STAFF RECOMMENDATION

1200 7th Avenue North

October 21, 2020

Application: New Construction—Infill (Revision to Previously-Approved Plans)

Figure 3. This site plan indicates the area where the second level will be added.

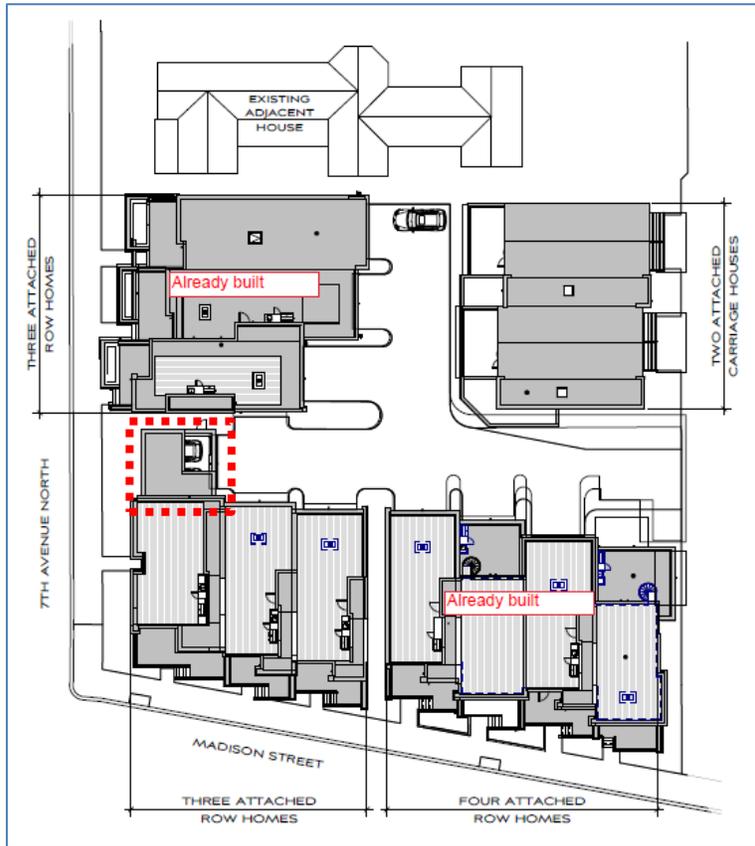
Height and Scale: The height and scale of the proposed townhouses will largely remain the same, with a few exceptions. The first proposed change is that a second level will be added to a rear portion of a townhouse facing 7th Avenue North that is currently one story in height (Figures 3, 4, and 5). This part of the townhouse will now be approximately

twenty-four feet (24') tall, and will still be lower in height than the townhouses. Staff finds that this two-story portion meets the design guidelines and the SP and does not affect how the townhouses' overall height and scale meet the historic context.

Figure 6 (Left) is the proposed revised Madison Street façade and Figure 7 (Right) is the previously approved plan.

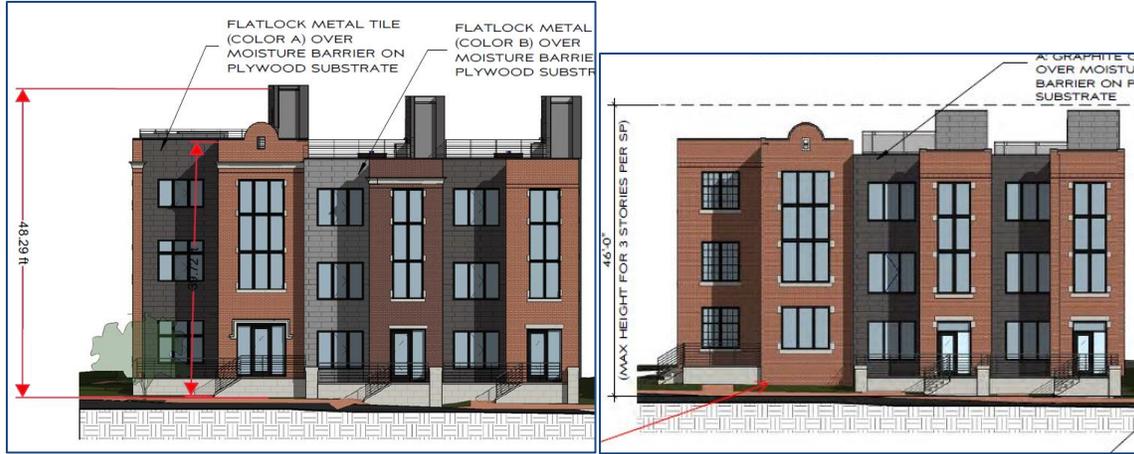
The second proposed change is that the stair bulkheads have been redesigned (Figures 6, 7, 8, 9). The new bulkheads angle back from Madison Street to help reduce their visibility. The new bulkheads do extend to make the structure 48' tall from grade, whereas the SP zoning approved a structure that is just 46' tall (Figure 10). Staff finds

the height of the stair bulkheads to be appropriate because the height of the primary massing remains at about forty feet (40') or lower. In addition, the angle of the bulkheads will make them less visible from the street. The extra two feet (2') of height will not detrimentally affect the overall height and scale of the townhouses.

Figure 10 (Left) is the proposed revision to the alley townhouses. Figure 11 (Right) is the previously approved plan

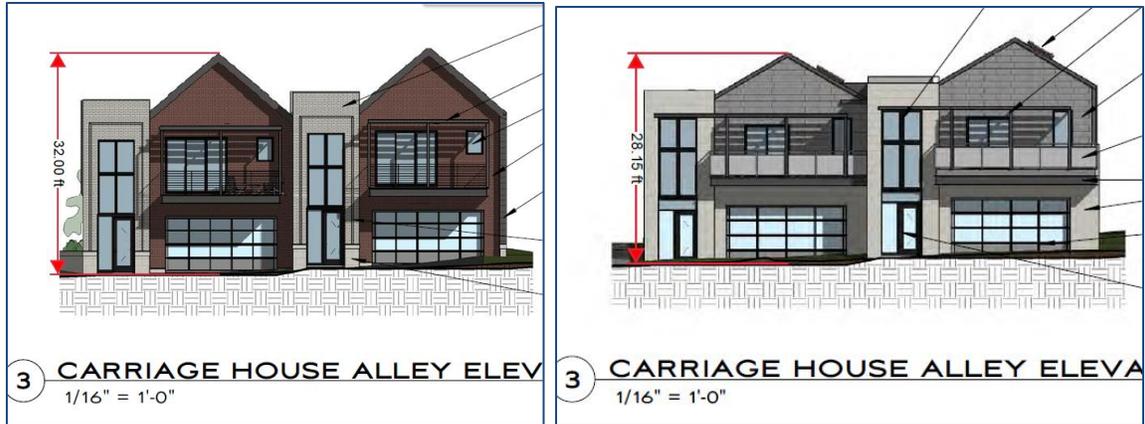
The height of the rear townhouses also changed slightly since the 2017 approval. The overall scale is the same, but the height increased from about twenty-eight feet (28') to approximately thirty-two feet (32') (Figures 10, 11). This is the result of a steeper-pitched gable. Staff finds this increase in height to meet the design guidelines because the extra height does not alter the two-story scale and still results in a rear structure that is lower in height and scale than the townhouses facing Madison Street and 7th Avenue North.

Staff finds that the proposed alterations to the townhouse’s height and scale meet both the SP plan and Section III.D. of the design guidelines.

The rear alley townhouses have a slightly higher pitched gable. The previously-approved plans had a pitch of about 6/12 and the proposed revisions have a pitch of about 8/12. Staff finds this change to meet the design guidelines and to be appropriate.

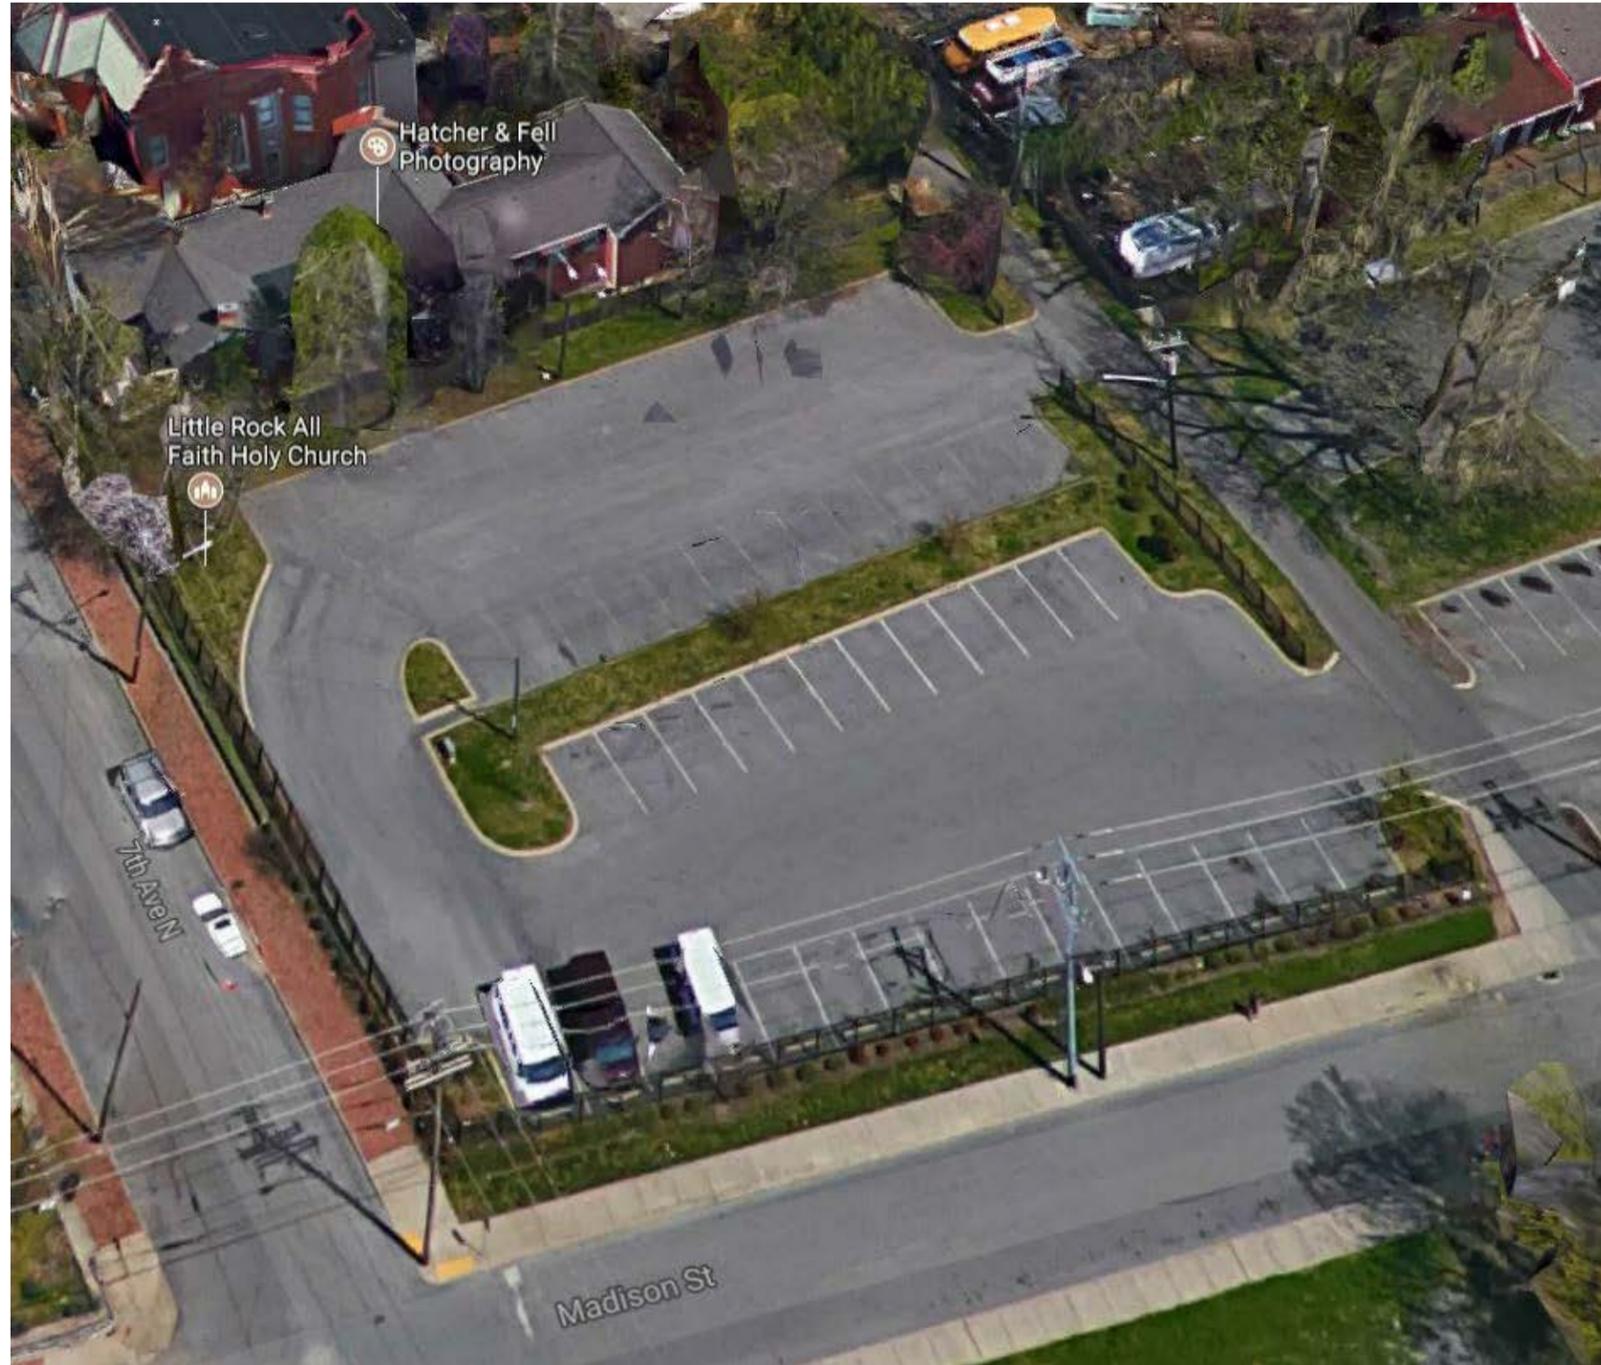
Orientation. The alterations to the approved plans include relocating the entrance for the corner unit from 7th Avenue North to Madison Street. Staff finds that this relocation is appropriate for a corner lot and will not affect how the townhouses relate with the streets.

Staff finds the alterations to the orientation to meets Section III.E.3. of the design guidelines.
